Response to #4 (aesthetics):

Response to #4 (aesthetics - continued):

Lloyd Beach – existing breakwater (red line indicates approximate height of proposed Breakwater for comparison)

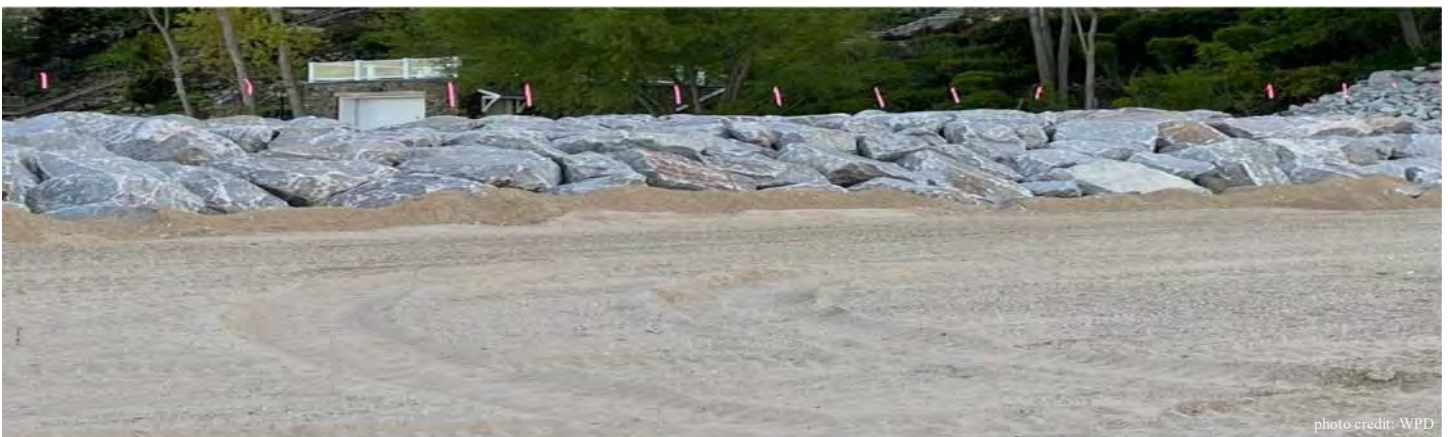
While the Lloyd Beach improvements have been very well received and accomplish the intended objectives, there remains room for aesthetic improvement. Construction of a full stone breakwater, like Lloyd Beach, that slopes up from the water to the toe of the bluff is too harsh and would create a “fortress” like feeling. The breakwater stones at the New Park and Beach will be lower than those at Lloyd and set at a consistent height so lake horizon and shoreline views are preserved. The red dashed line in the following photo indicates the approximate height of the new breakwater in relationship to the one at Lloyd.
